Access Compliance Report

Public Rights-of-Way

(Curb Ramps)

Intersection ID: 25192	Main Street: CANE_FIELD_DR	Cross Street: ROLLING_SKY_DR	Location: NW
ADA ID: F96E9FF873BF	Ramp Type: PerpDiag	Initial Pass/Fail: Fail	Overall Compliance: No
		Severity Score: 25

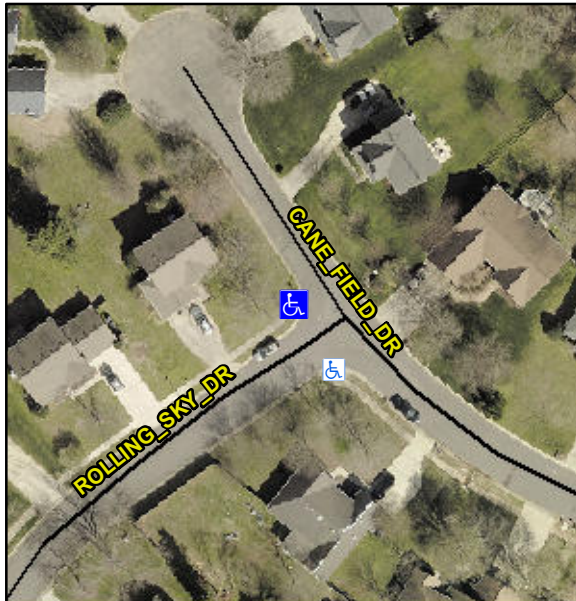
Not Found, R304.2.2

Compliance	Description	Data	Compliance	Description	Data
N/A	Ramp Length (in)	51.0	No	Ramp Slope (%)	14.4
Yes	Ramp Width (in)	48.0	Yes	Ramp XSlope (%)	0.6
N/A	Flare Type LT	N/A	N/A	Flare Type RT	N/A
N/A	Flare Slope LT (%)	N/A	N/A	Flare Slope RT (%)	N/A
N/A	Flare Traversable LT?	N/A	N/A	Flare Traversable RT?	N/A
N/A	Landing Length (in)	N/A	N/A	DWS Provided?	N/A
N/A	Landing Width (in)	N/A	N/A	DWS Contrast?	N/A
N/A	Landing Slope (%)	N/A	N/A	DWS Length (in)	N/A
N/A	Landing X Slope (%)	N/A	N/A	DWS Full Width?	N/A
N/A	Landing Curb? (Y/N)	N/A	N/A	DWS Offset (in)	N/A
N/A	Shared Landing?	N/A			
N/A	Gutter Ponding?	N/A	N/A	Gutter Slope (%)	N/A
N/A	Gutter Lip Ht (in)	N/A	N/A	Gutter X Slope (%)	N/A
N/A	Painted X Walk1?	No	N/A	Painted X Walk2?	No
	X Walk 1 Direction	To SE		X Walk 2 Direction	To NE
N/A	X Walk 1 Width (in)	N/A	N/A	X Walk 2 Width (in)	N/A
	X Walk 1 Slope (%)	1.0		X Walk 2 Slope (%)	1.3
	X Walk 1 X Slope (%)	1.2		X Walk 2 X Slope (%)	0.9

Remove & Replace Curb Ramp With Two New Directional Ramps or Equivalent.
